Land at Bird in Eye Farm
South of Bird in Eye Hill
Uckfield

TRANSPORT ASSESSMENT ADDENDUM

ITR/MT/5330/TAA.4
March 2022

CLIENT	Croudace Homes Ltd.	DATE	03/03/22
PROJECT	Bird in Eye, Uckfield	DESIGN BY	-
TITLE	Swept Path Analysis Refuse Vehicle Priority T-Junction (Option 1)	DRAWN BY	ARM
		CHECKED BY	MT
		SCALE	1:500 @ A3
DRAWING No.	5330 / 230		REV No. A

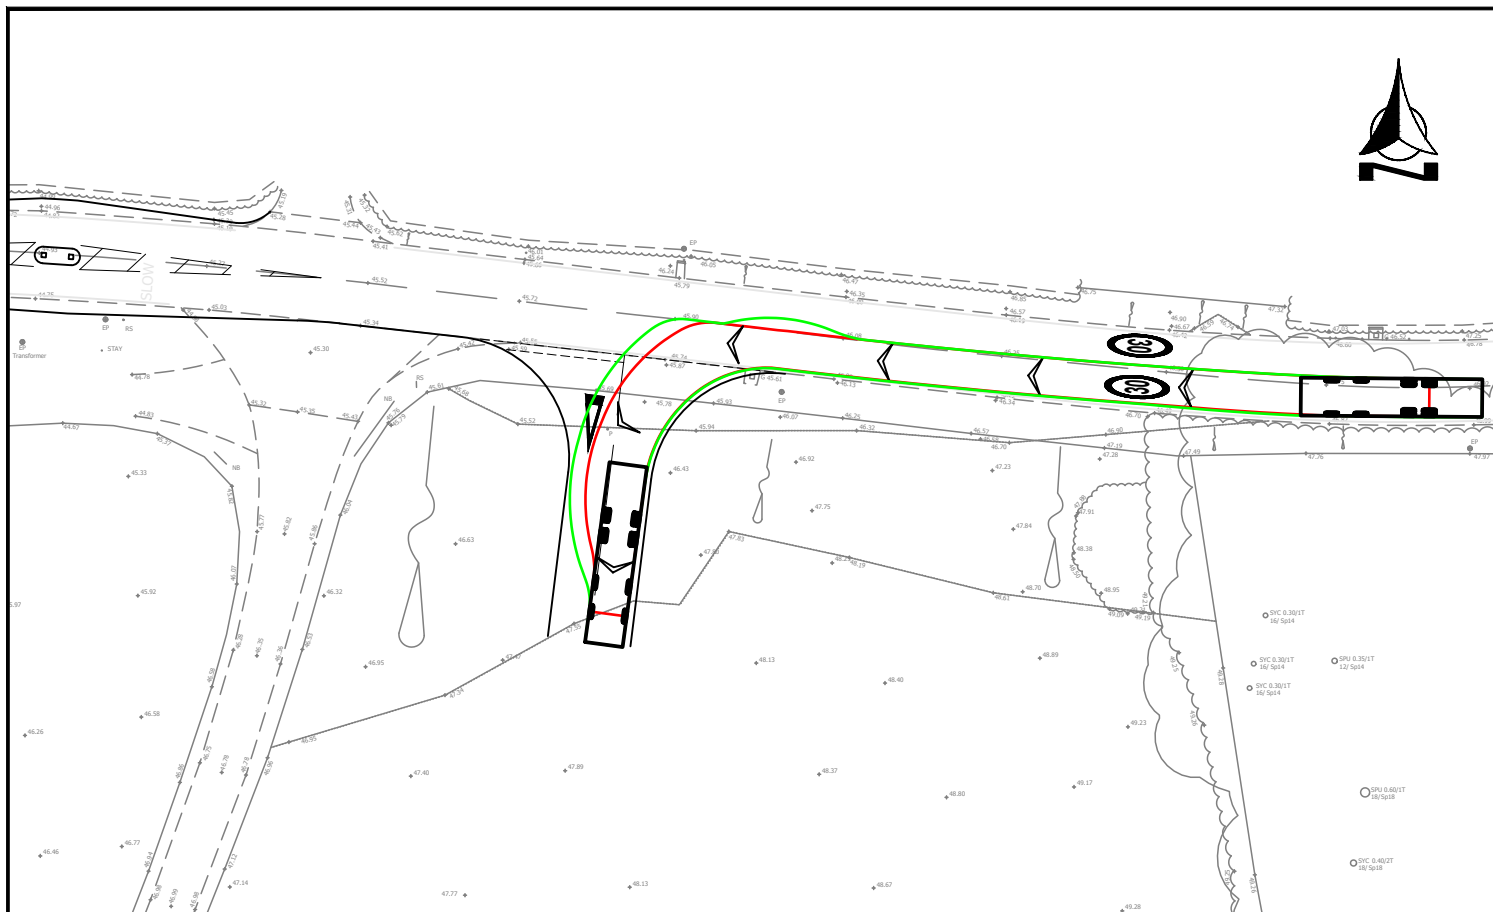
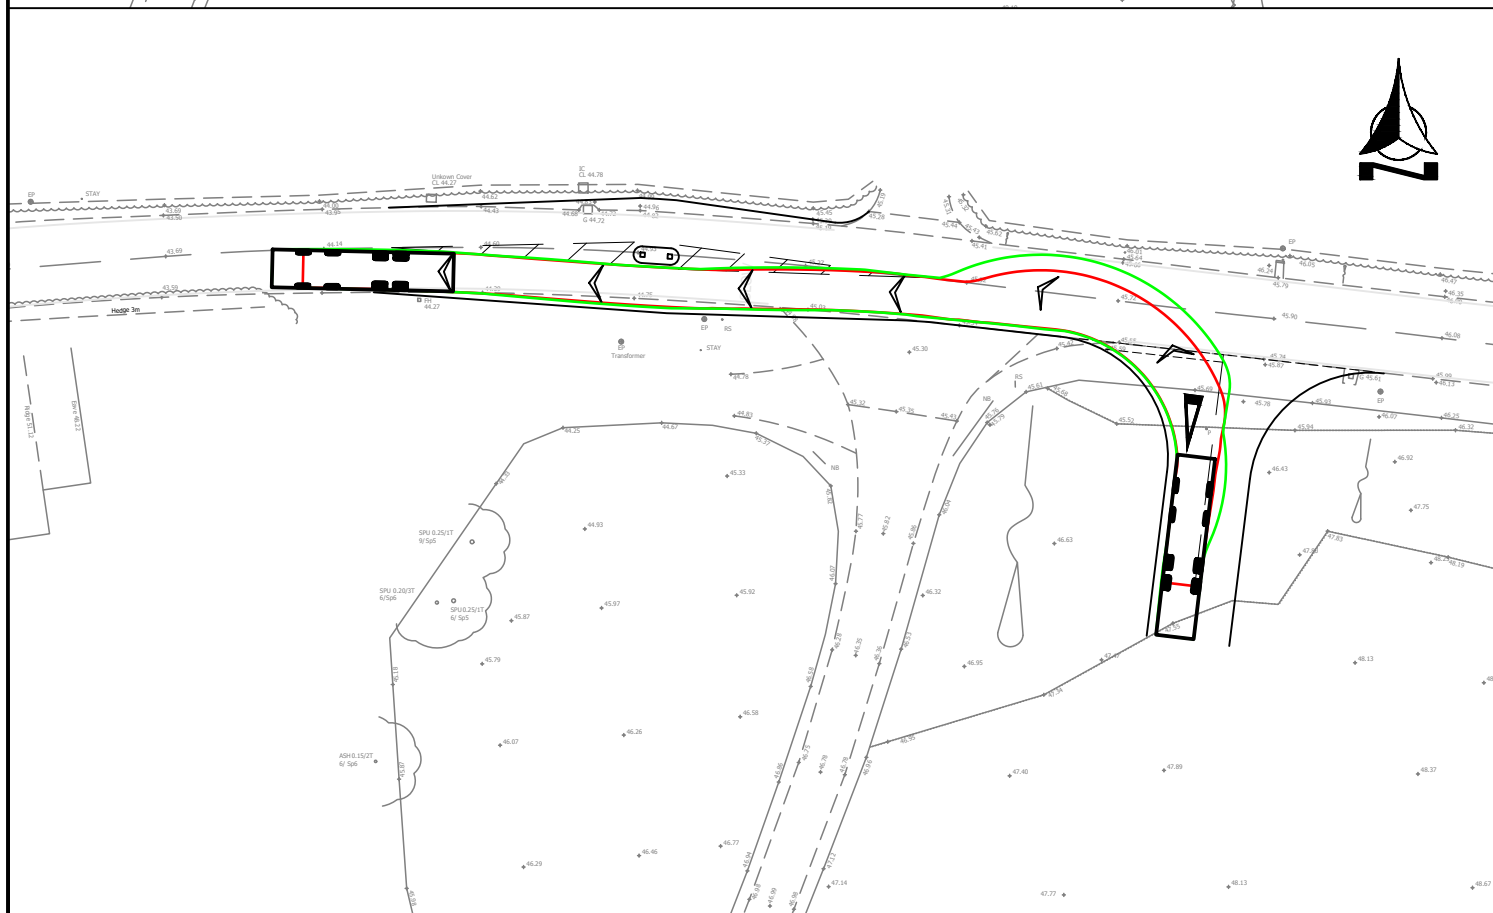
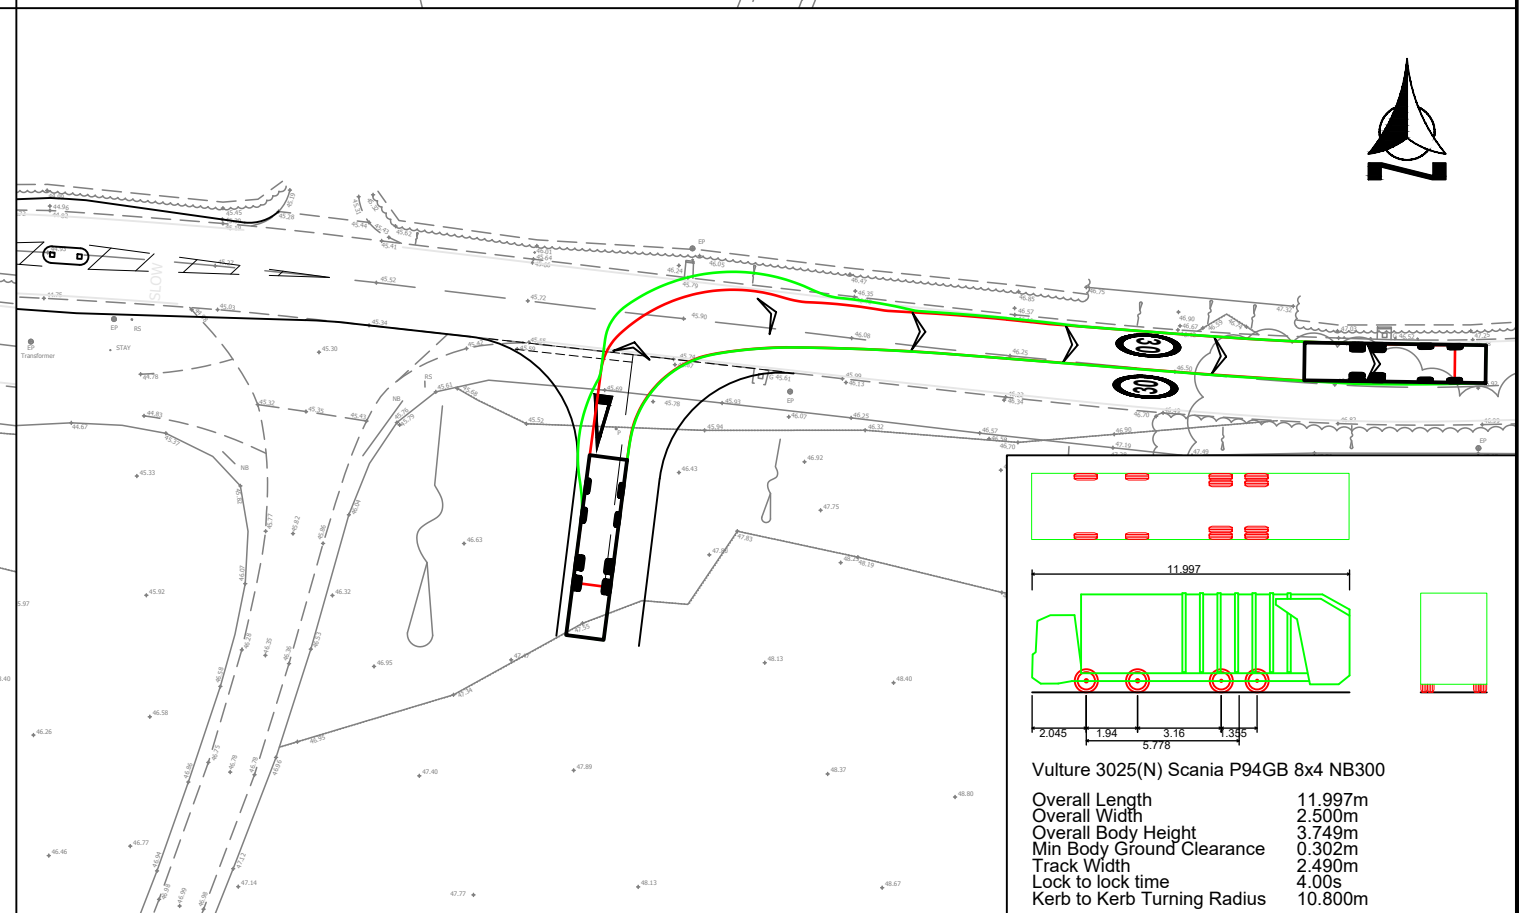
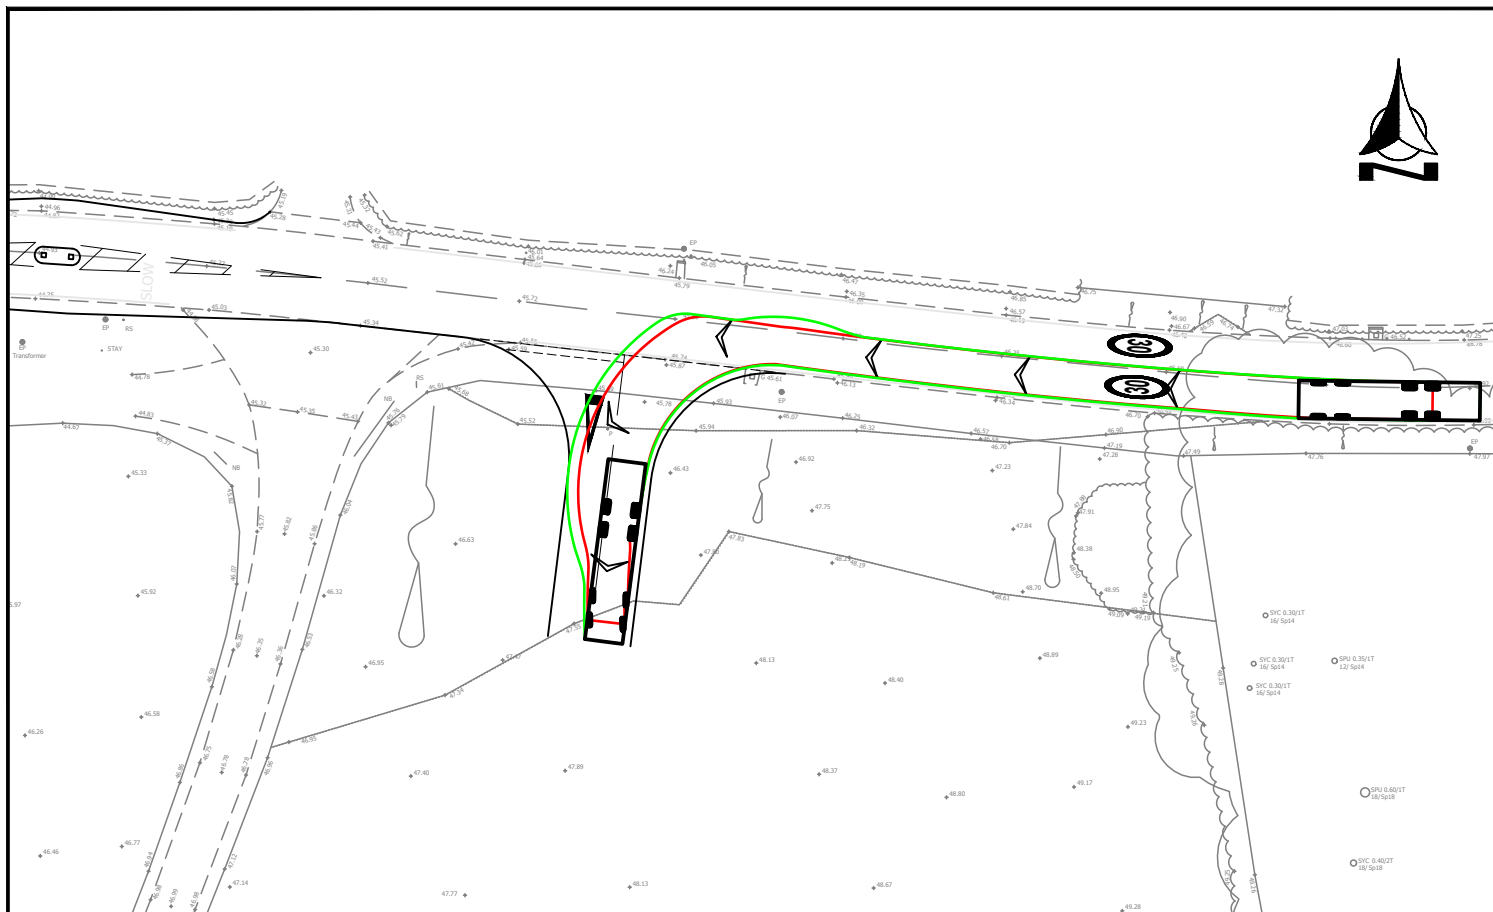
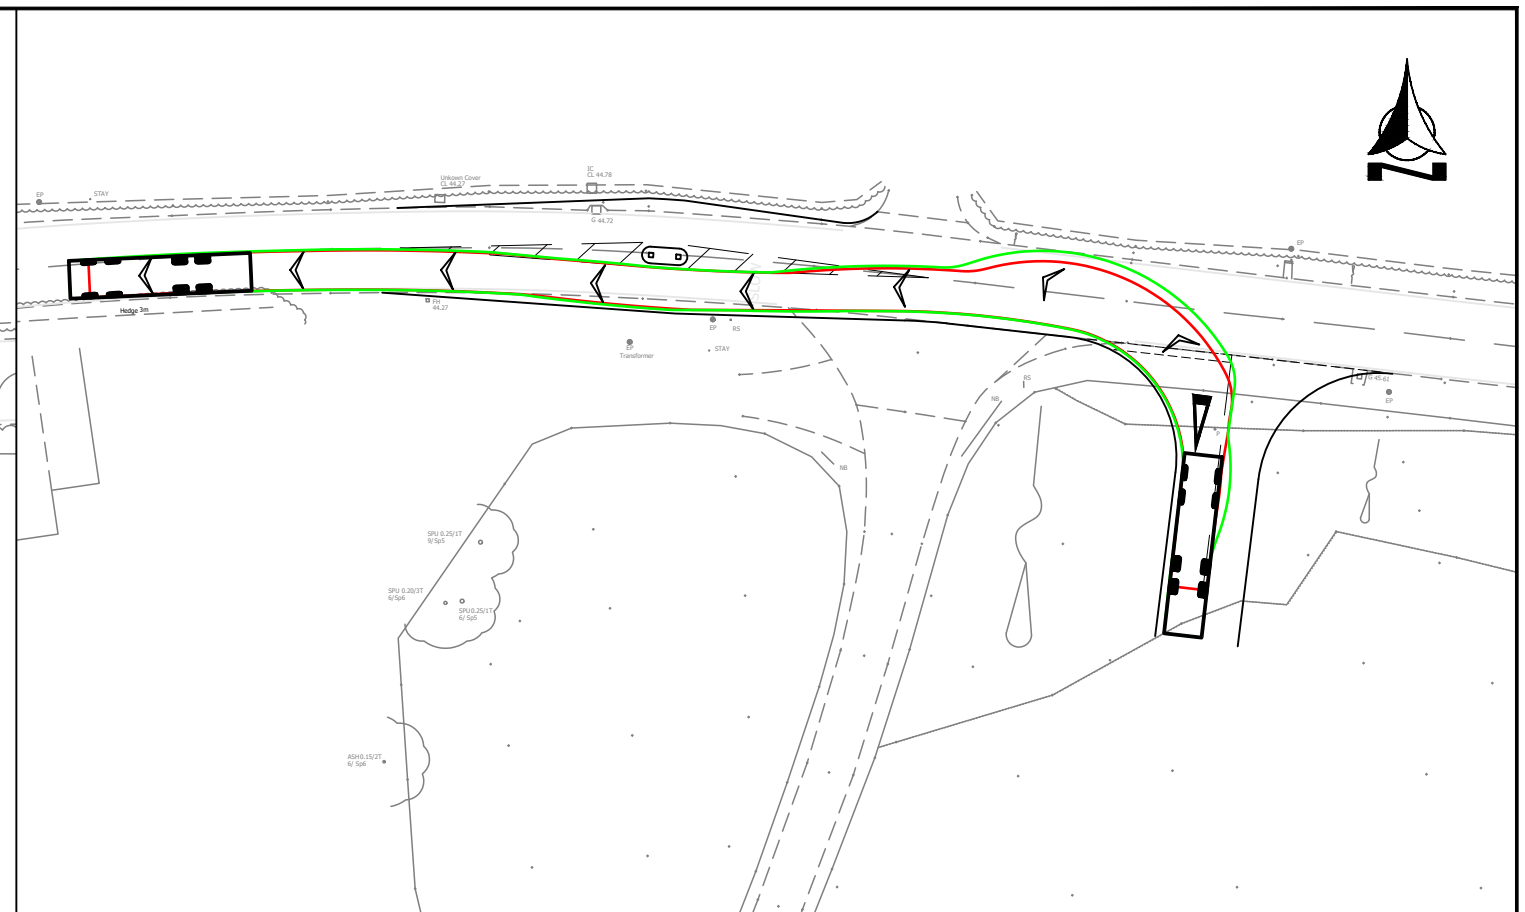
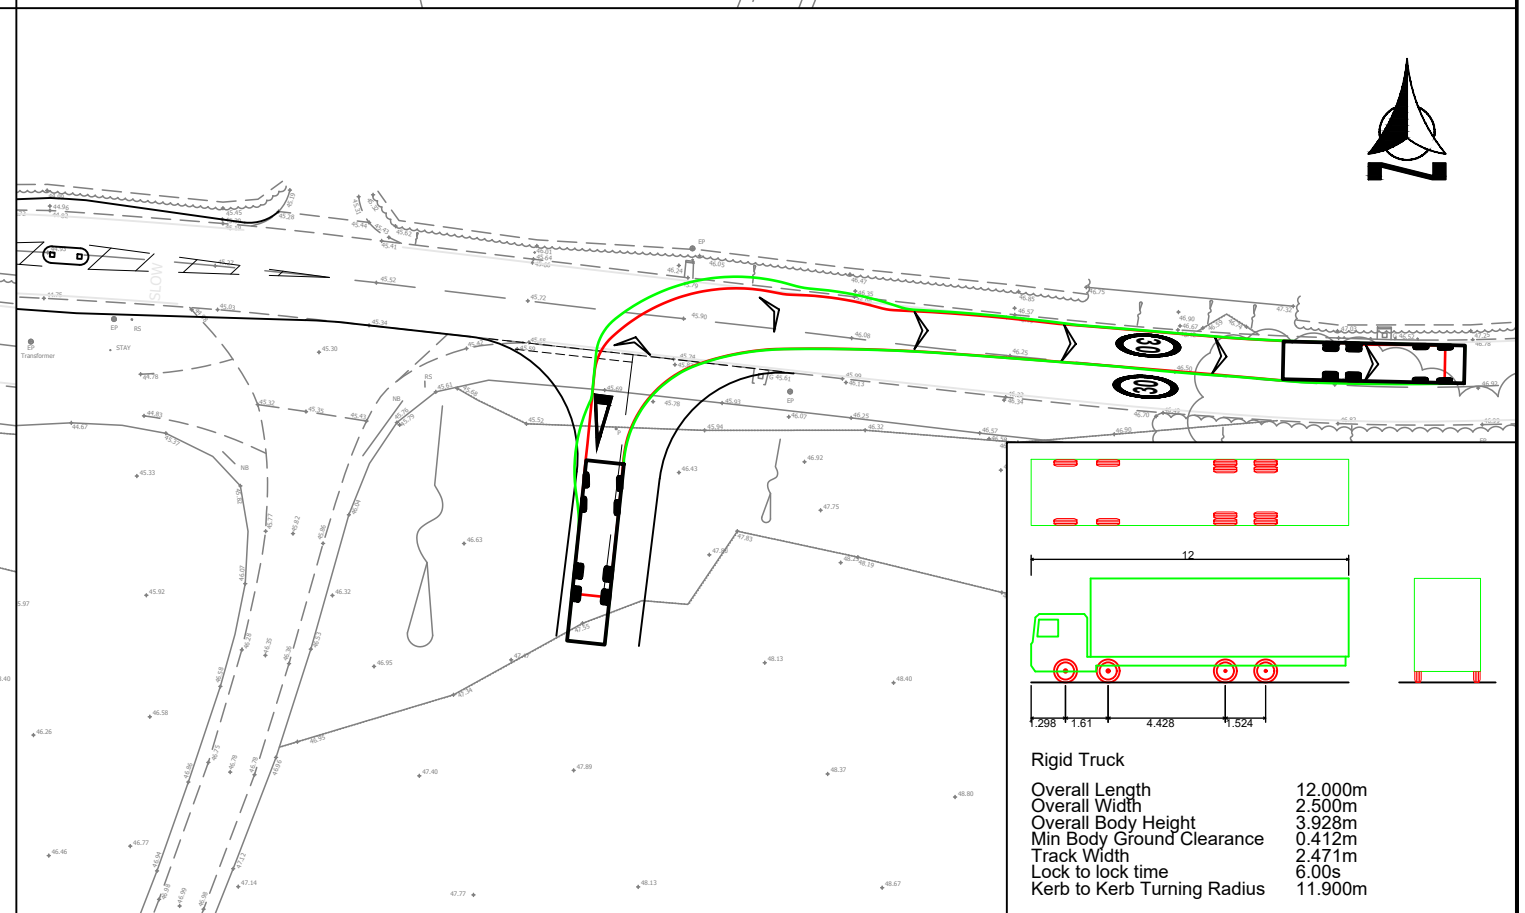
Auditor Comment: Insufficient space may be provided to allow service vehicles to enter. The existing access to Bird in Eye Farm is approximately 5 metres wide with large corner radii that allow for Heavy Goods and Agricultural Vehicles to manoeuvre safely. The proposals include the relocation of the priority access with 8 metre corner radii which provides access to a 5.5m wide carriageway. No swept path analysis has been provided with the Audit Brief and as such, the corner radii may not be sufficient to allow for the infrequent HGV movements that could be expected from a development of 300 dwellings. Should turning movements be restrictive, vehicles could be required to encroach the opposing lane or vehicles may be required to reverse out of the proposed access or in order to enter and exit the access raising the risk of rear-end, sideswipe collisions.

BR Response: Additional swept path analysis has been undertaken of the site access (see **Appendix 7**).

Designer Response: A swept path analysis has been undertaken and the proposals are adequate for the expected vehicles.

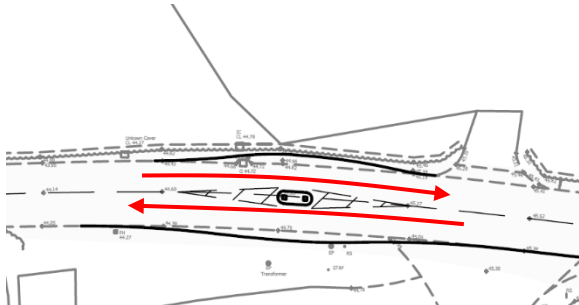
A.1	LOCAL ALIGNMENT
A.1.1	PROBLEM
Location:	Proposed access
Summary:	Vehicles may approach Bird in Eye Hill at inappropriate speeds
Acc Type:	Junction overshoot
<p>The application site is currently set at a level above the adjacent Bird in Eye Hill with the existing access rising gradually away from the main carriageway. The proposals relocate the existing access to Bird in Eye Farm in order to serve a proposed development of 300 residential dwellings as well as two existing dwellings outside of the application site. The scheme drawings do not identify the gradient of the proposed carriageway at this stage, however, the land in proximity appears to be approximately 2 to 2.5 metres higher than the level of the existing carriageway. A gradient in excess of 1 in 20 on approach to a simple priority access could lead to junction overshoot type incidents.</p>	
RECOMMENDATION:	
It is recommended that the access road is set at a maximum gradient of 4%

<p>Location Plan:</p>  	
<p>DESIGN ORGANISATION RESPONSE provided by Bellamy Roberts on the 24th March '22 following formal issue of this Stage 1 Road Safety Audit on the 23rd March '22</p>	
<p>The proposed access will be designed with a 4% or slacker gradient in accordance with standards with the land either side, graded up away from the carriageway at an appropriate gradient.</p>

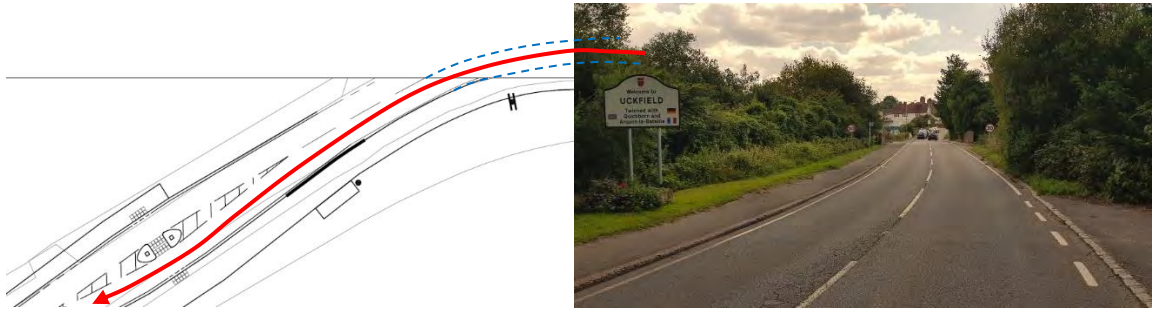
A.1.2	PROBLEM
Location:	Bird in Eye Hill – at proposed access
Summary:	Tapers of the proposed island are too sharp
Acc Type:	Sideswipe type collision
<p>The B2102 Bird in Eye Hill is a two-way single carriageway road that is derestricted and therefore subject to the 60mph but according to data contained within the Audit Brief, observes 85th percentile eastbound speeds of 39.9mph and westbound speeds of 43.4mph. The proposals include the provision of a priority access off the southern side of the carriageway and splitter islands to the west provided through widening the carriageway to the north. Measurements taken off the scheme drawing provided with the Audit Brief, identify that the proposed splitter islands are 1 metre wide and formed with 8 metre tapers to a 0.3 metre offset. It can therefore be determined that the tapers are to be set at 1 in 5 which will not provide a smooth alignment for approaching vehicles. Traffic could therefore clip the kerb which may lead to loss of control type collisions</p>

RECOMMENDATION:	
It is recommended that adequate tapers are provided in accordance with CD123	
Location Plan:  	
DESIGN ORGANISATION RESPONSE provided by Bellamy Roberts on the 24th March '22 following formal issue of this Stage 1 Road Safety Audit on the 23rd March '22 <p>The taper length associated with each proposed traffic island has been increased. See drawings 5330/008 rev. E and 5330/020 rev. C.</p>	
A.1.3	PROBLEM
Location:	Bird in Eye Hill
Summary:	Proposed alignment generates a reverse curve
Acc Type:	Loss of control type collision
<p>The B2102 Bird in Eye Hill accommodates a bend in the road to the east of the access to Uckfield Community Hospital. The proposals include the provision of a refuge island to the west of the existing bend in the road that is to be 2 metres wide and formed with circa 15 metre tapers through widening on the southern side of the carriageway. It can therefore be determined that the tapers are to be set at 1 in 7.5 which follows the bend in the road and generates a reverse curve which will not provide a smooth alignment for approaching vehicles. A westbound vehicle could strike the proposed refuge or nearside kerb following the feature leading to loss of control type collisions.</p>

DESIGN ORGANISATION RESPONSE provided by Bellamy Roberts on the 24 th March '22 following formal issue of this Stage 1 Road Safety Audit on the 23 rd March '22	
Agreed. The channel line along the southern side of the carriageway has been adjusted, and the taper extended to provide a smoother alignment (see drawing 5330/016 rev. E)	
A.2	GENERAL
A.2.1	PROBLEM
Location:	Bird in Eye Hill
Summary:	Drivers approaching the proposed traffic island may not become aware of the feature at a safe distance
Acc Type:	Vehicle loss of control
<p>The B2102 Bird in Eye Hill is a two-way single carriageway road that is derestricted and therefore subject to the 60mph but according to data contained within the Audit Brief, observes 85th percentile eastbound speeds of 39.9mph and westbound speeds of 43.4mph. The proposals that are subject to this Stage 1 Road Safety Audit includes the provision of a simple priority access off the southern side the carriageway and a splitter islands to the west which is to ensure that eastbound vehicles approaching the proposed access do not encroach the opposing lane and thus ensure the achievable visibility accords observed speeds. The scheme drawing illustrates that illuminated keep left bollards are to be provided which should highlight the features to approaching drivers, however, due to the existing alignment of Bird in Eye Hill to the west as well as vegetation abutting the carriageway on the southern side, forward visibility for eastbound drivers is limited. As such, there may be insufficient warning of the traffic island which could lead to vehicles striking the feature and a loss of control type incidents.</p>
